WEBB WHEEL PRODUCTS, INC.

SERVICE BULLETIN NO. 45

BRAKE DRUMS:	65540	65545
	65541	65546
	65542	65547
	65543	65549

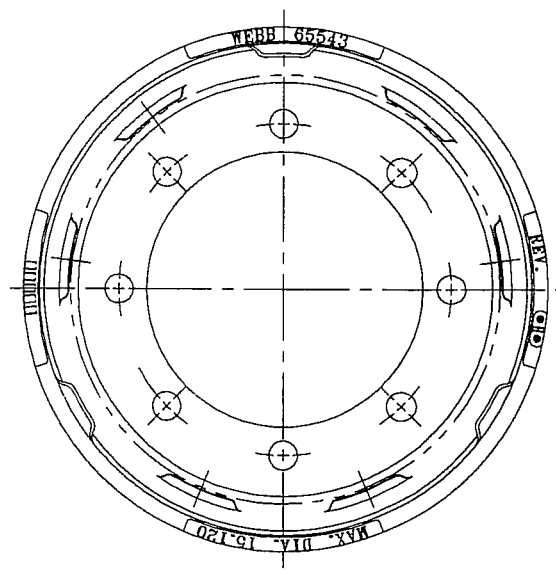
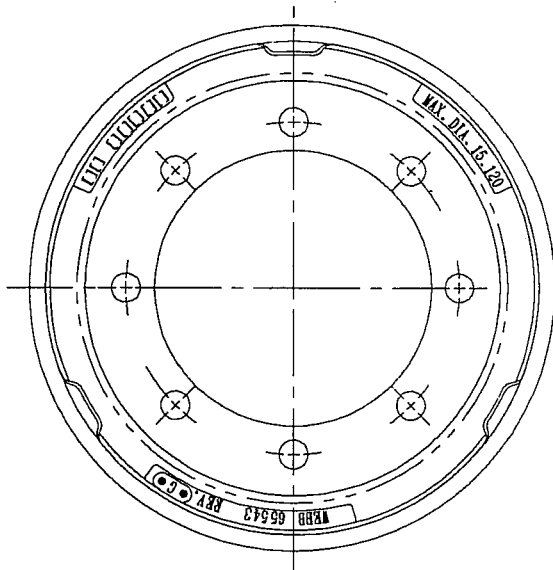
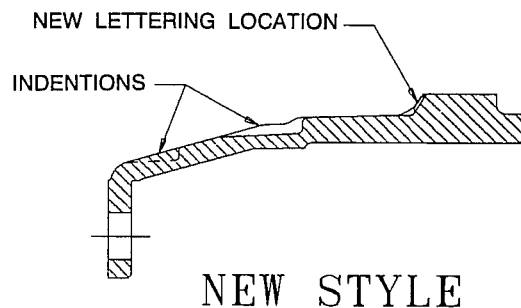
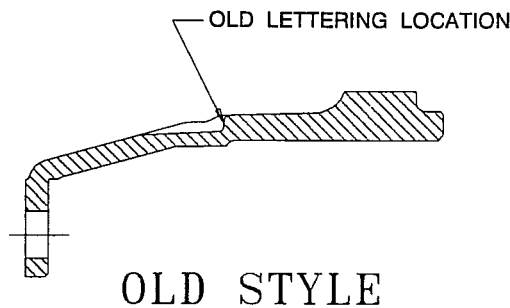
The exterior profiles of the brake drums listed above have been changed to accommodate the implementation of new machining procedures in our manufacturing facilities. The change amounts to the relocation of the casting identification lettering to the band area and the incorporation of several indentions in the drums for machining purposes only.

These changes affect the cosmetic appearance of the drum exterior only and do not affect the fit, form, function or interchangeability of these drums. Old style and new style drums may be mixed on a vehicle without affecting brake balance or performance.

The visual difference between the old and new style brake drums is highlighted on the illustrations above. Please feel free to contact our Product Engineering Department if you have any questions regarding this change.
